RAI 03.07.02-24, Supplement 1, Revision 1**QUESTION:****Follow-up Question to RAI 03.07.02-15 (STP-NRC-100036)**

UHS Basin and RSW Pump House:

RSW Piping Tunnel:

Figure 3H.6-232: Active Lateral Earth Pressure on the UHS Basin Walls

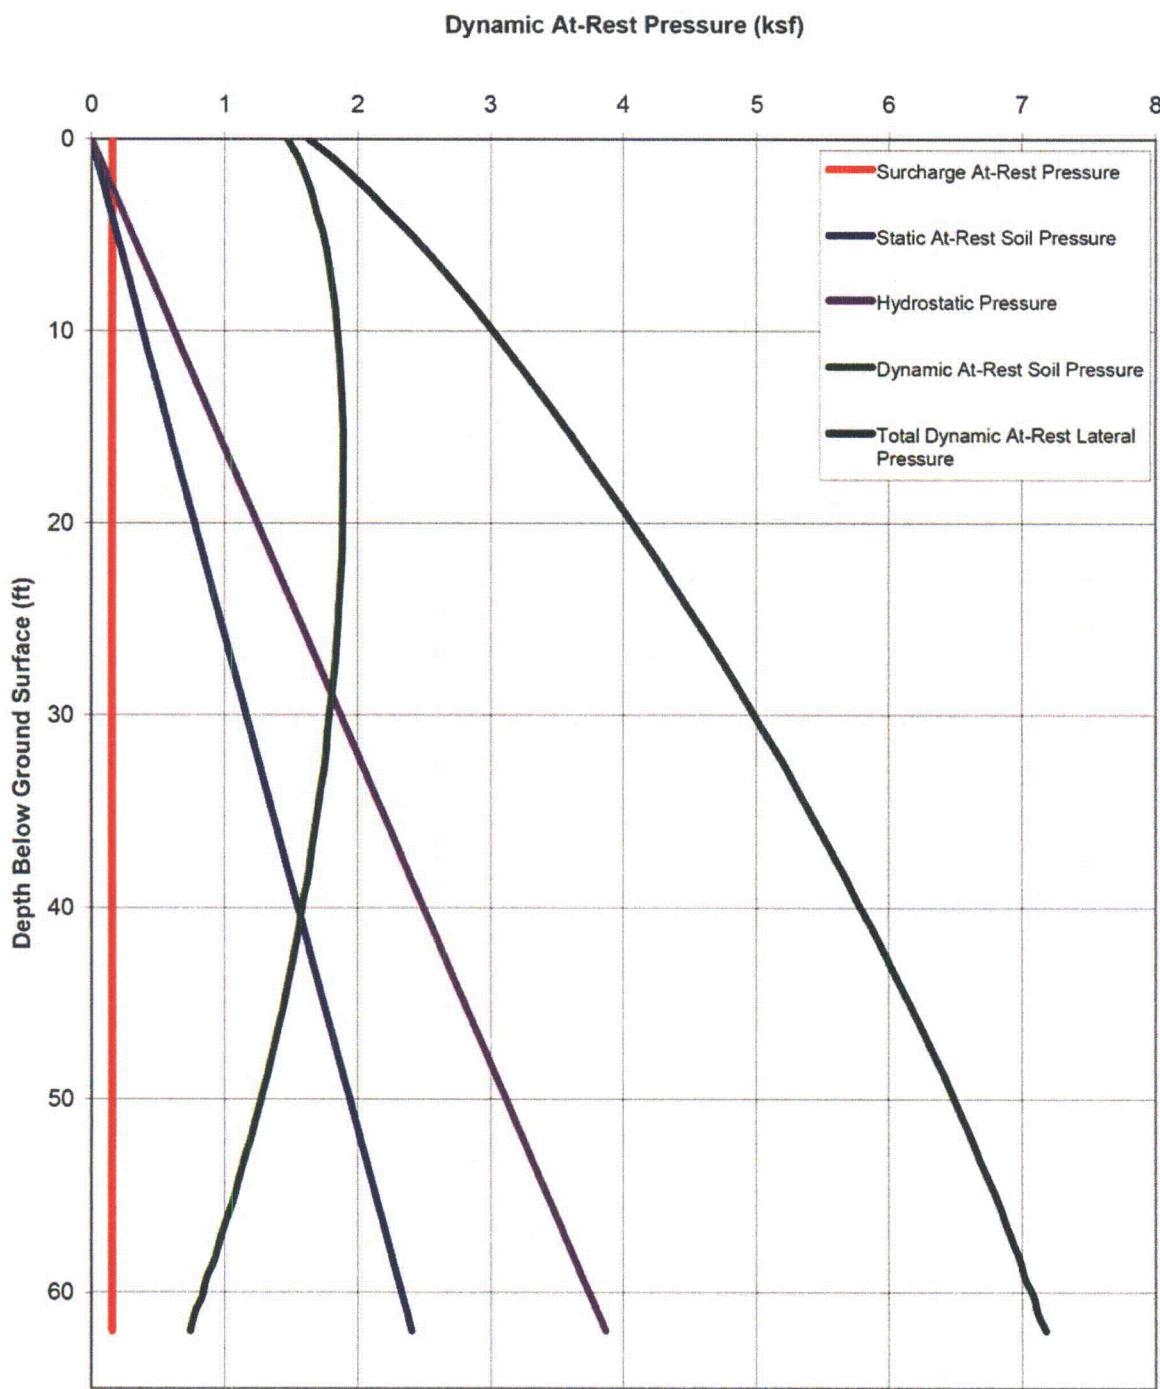
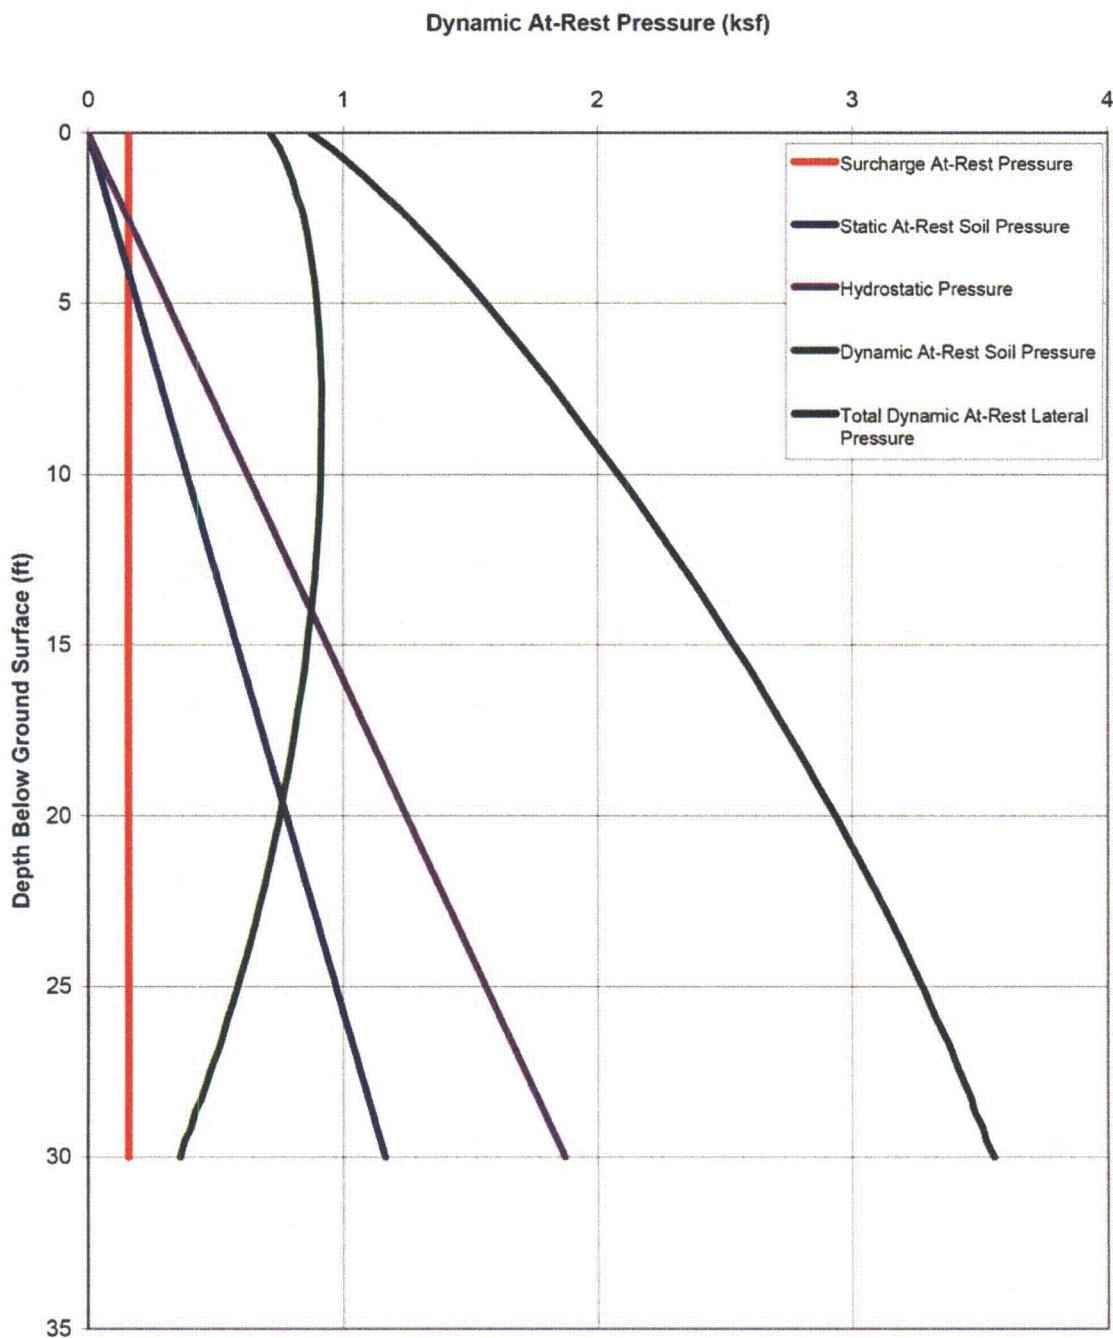
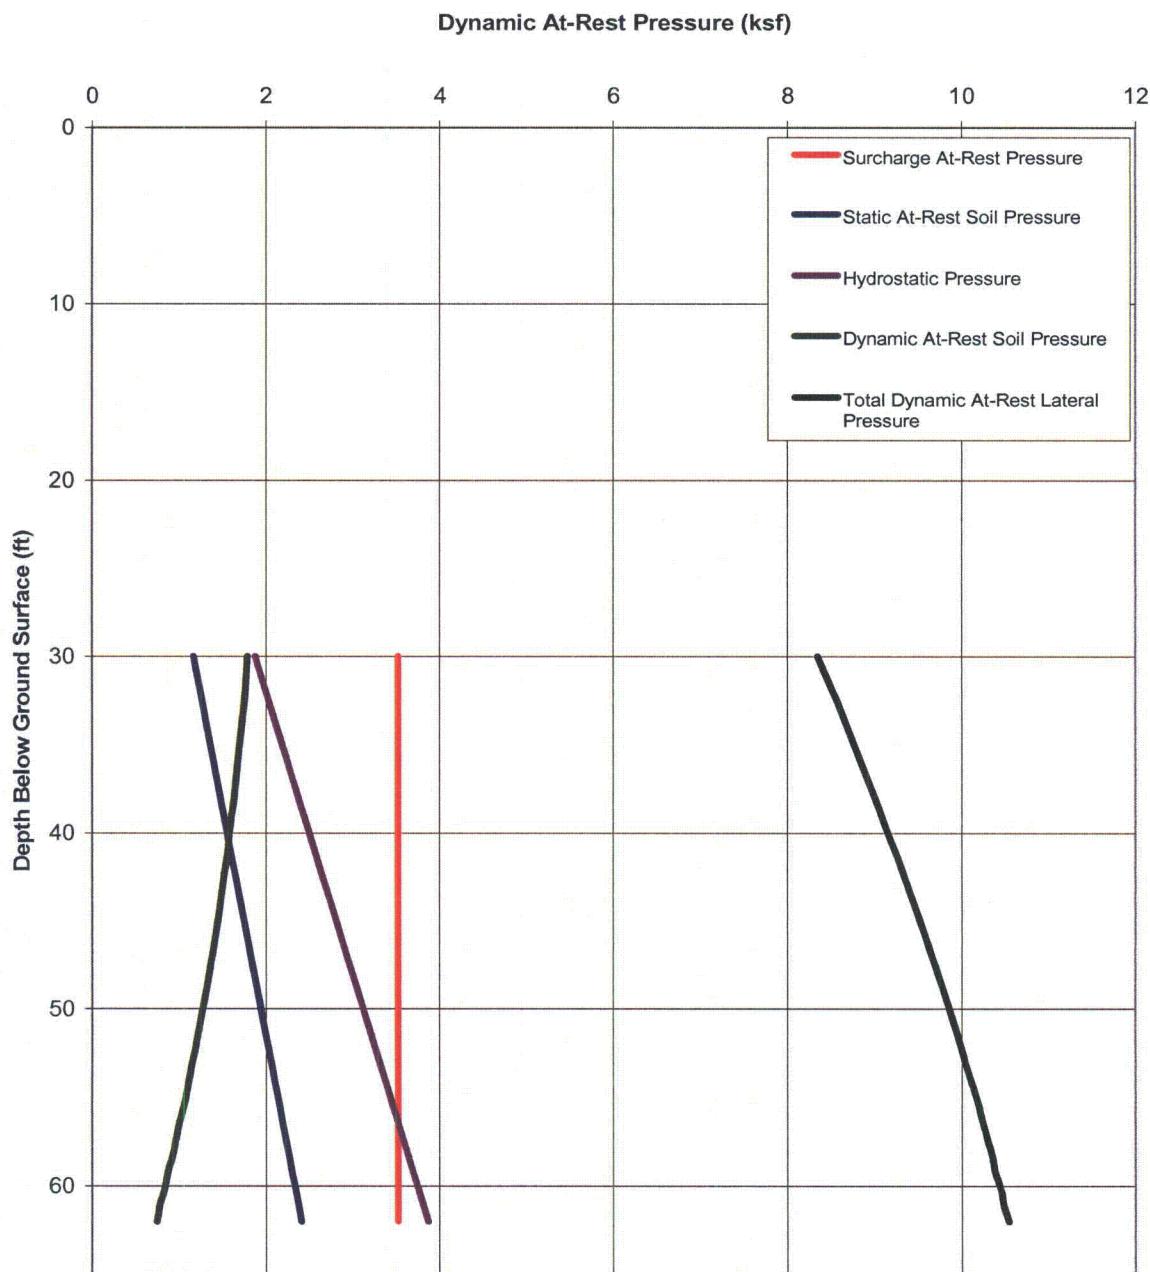
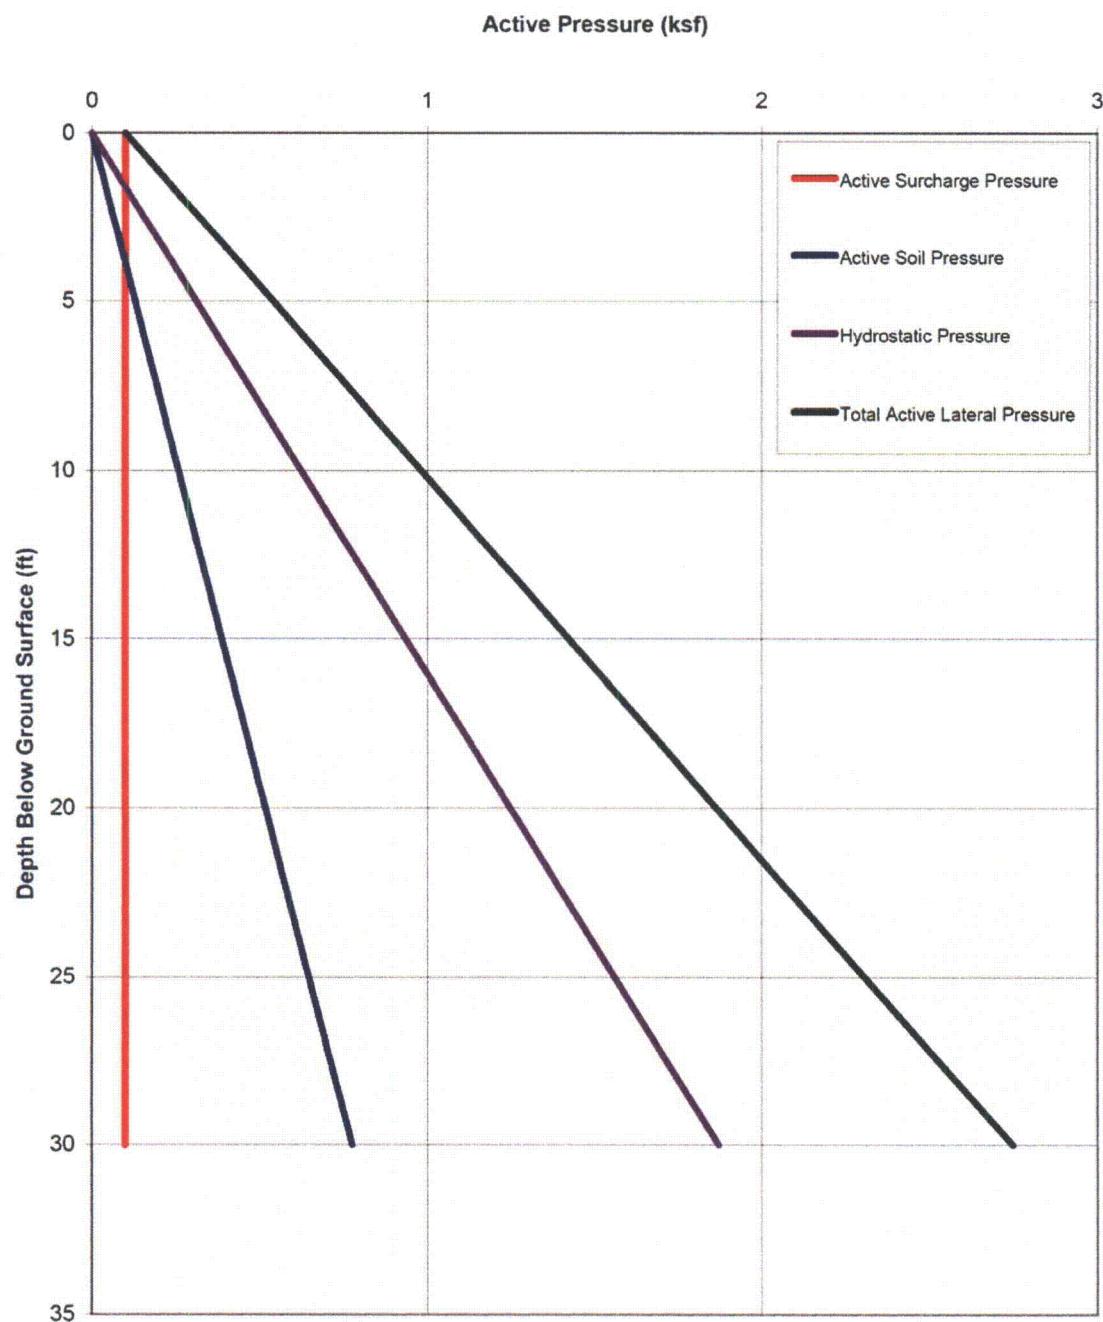
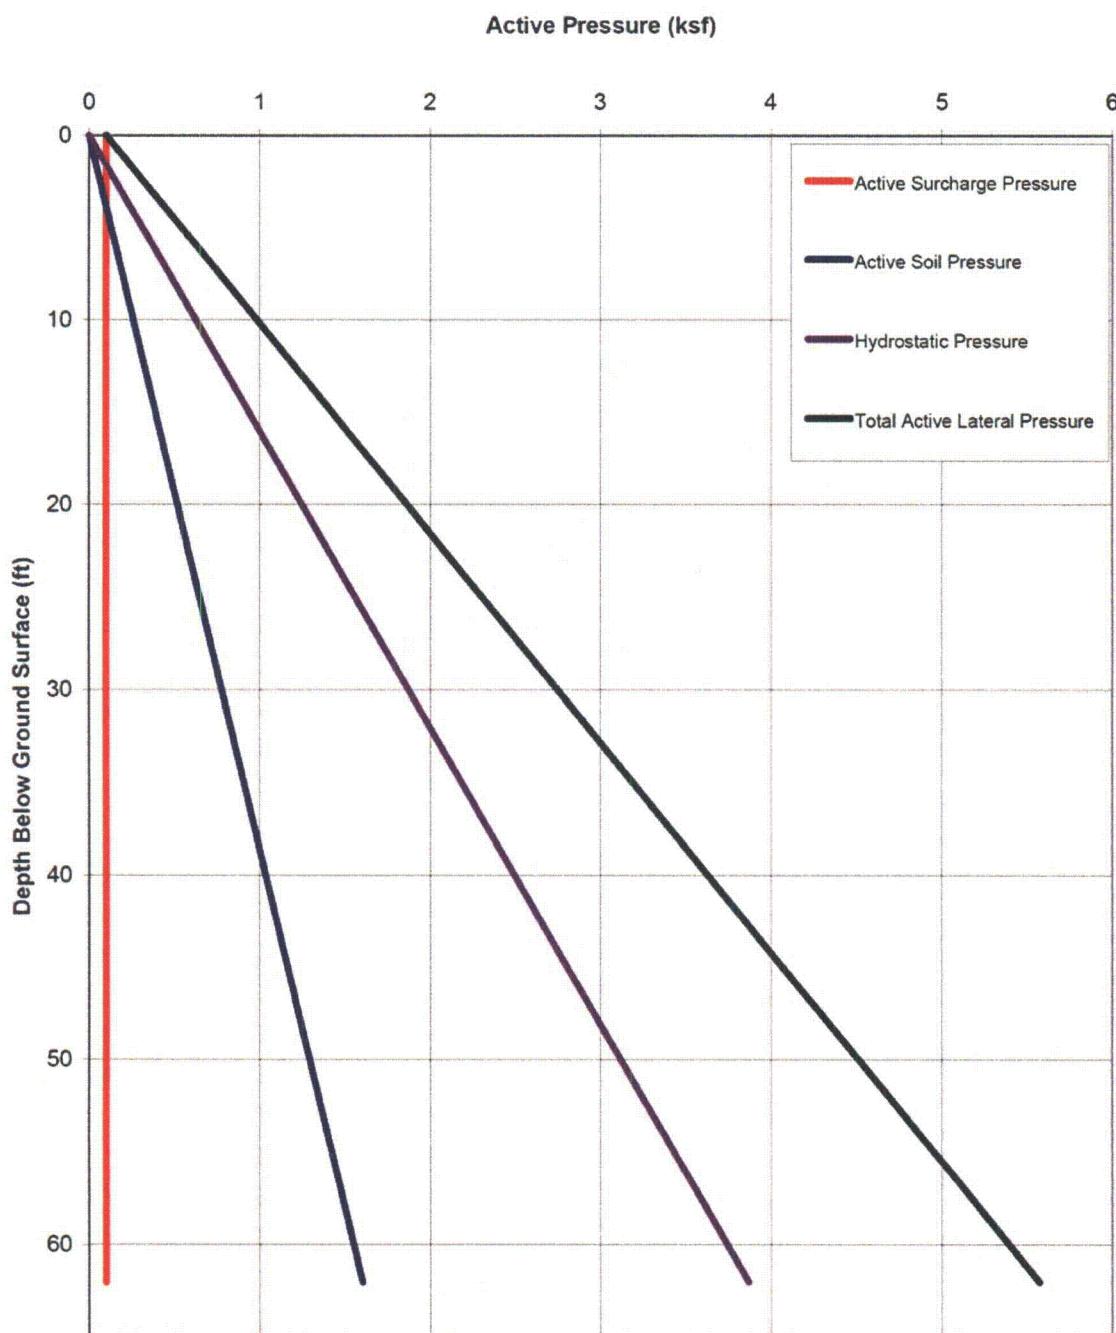
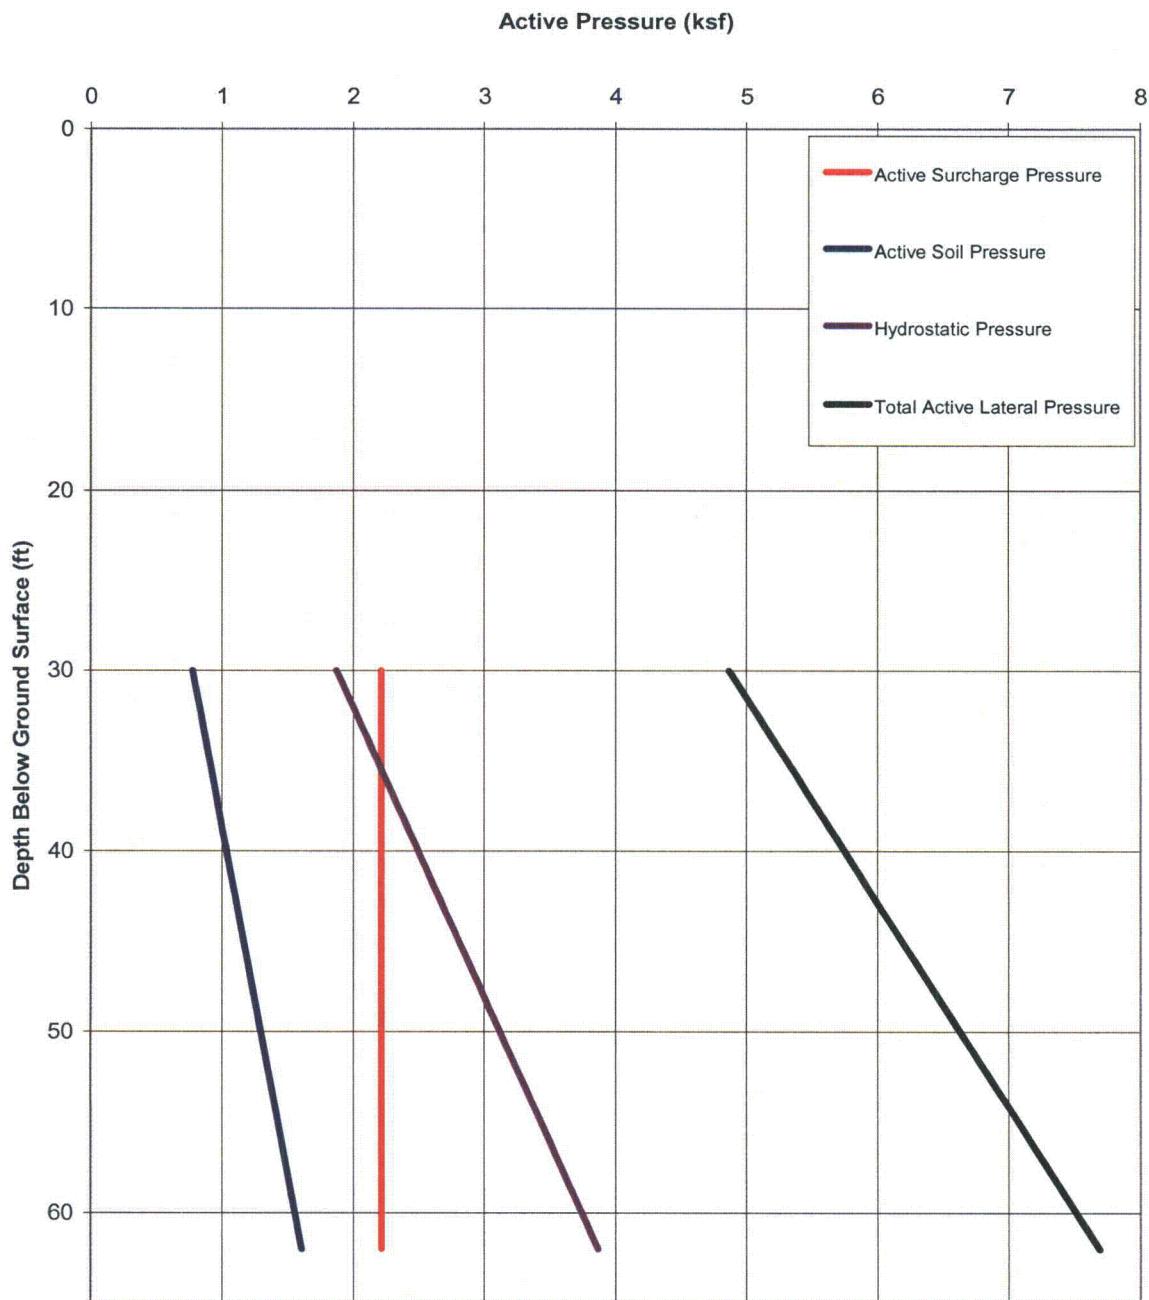
- b) For the staff to conclude that the design of structures with deep foundations, such as the Reactor Building (RB) and Control Building (CB), is satisfactory for the site, the site-specific design loads are needed to compare with the design loads used for the DCD. Lateral soil pressure is one such load. Therefore, please provide the lateral soil pressures for the RB and the CB, and compare these calculated pressures with those used in the ABWR standard plant design. Please also confirm if the effects of adjacent structures are considered in computing the lateral soil pressures, and if not, provide the justification for not doing so.

The SSSI incremental seismic soil pressure curves for the Ultimate Heat Sink (UHS) and RSW Pump House will be provided in response to RAI 03.07.02-22, currently scheduled to be submitted by March 15, 2011. The at-rest, dynamic at-rest, active, and passive soil pressure profiles are provided in Figures 3H.6-41 through 3H.6-43 and 3H.6-232 through 3H.6-240, included in Enclosure 1 of this response.
